Image presented at the
Informational Meeting in April

Nakoosa Trail Public Works Facility
Madison, Wisconsin

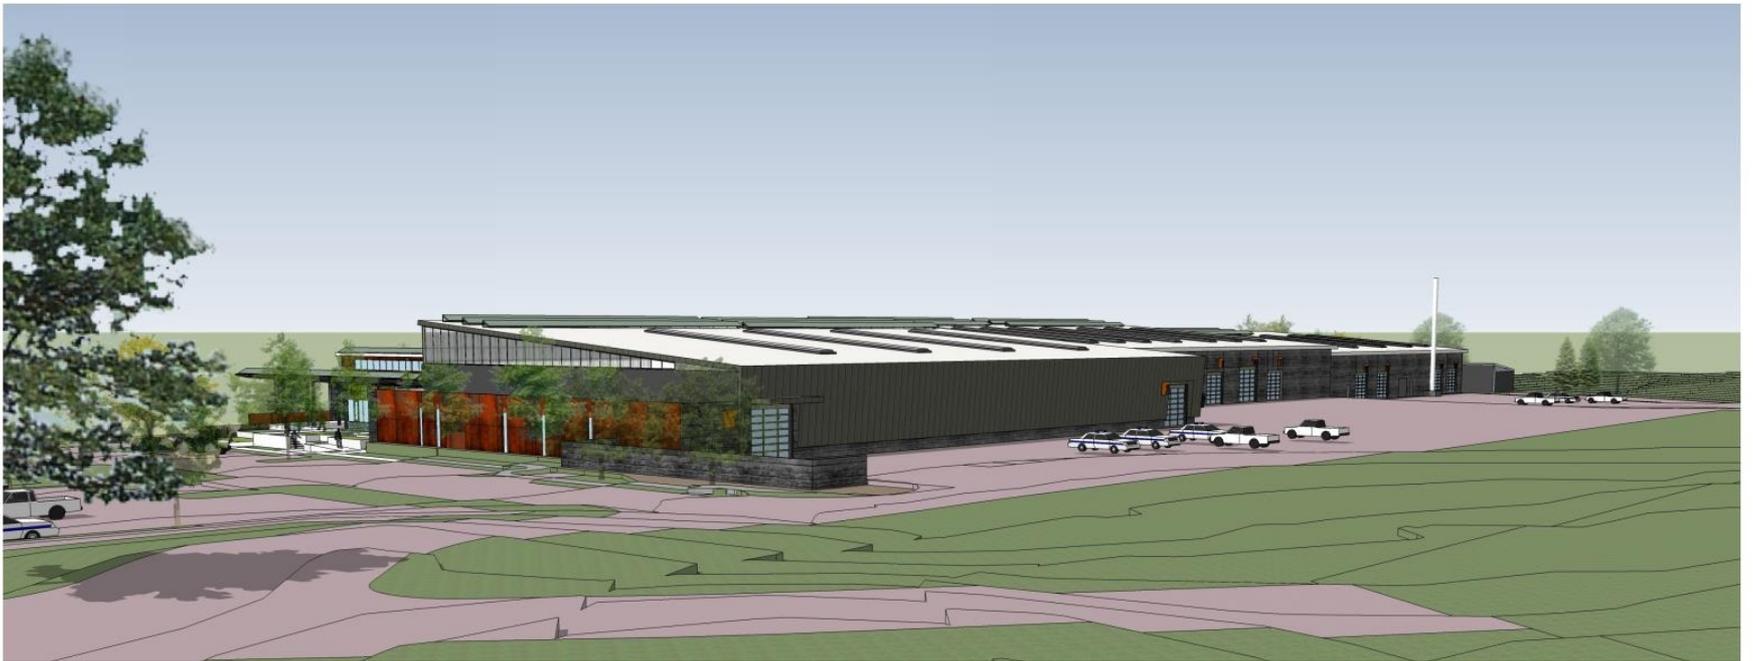
- When you return for final approval, please model the berms and fence details to get a better idea of the building view from the street.
- You need to mitigate the heat island affect. We have a policy of a tree for every 12 parking stalls.

- Employee and visitor parking will require trees in the islands, but the large vehicle parking would be exempt from the landscape requirements.
- Consider a more direct route.

- Consider angled parking along one-way drives.
- We need to see existing conditions on the site plan to get an idea of the existing natural landscape.
- Is the intent of the fence to protect vehicles parked outside after hours?

- Primarily yes.
- It looks like you pushed the public entrance closer to Nakoosa and you have more building along Nakoosa, which more publicly addresses that street. If it were possible for you to maintain your fencing where the fleet parking is actually located, and if possible bring the gate to exit on the east side of the site closer, it would make the front public face along Nakoosa feel more public. And if it's possible to omit the tight drive between the administration and Nakoosa, it's just not necessary in terms of separating circulation between the two, that would also make it appear like a more public building with just landscaping.
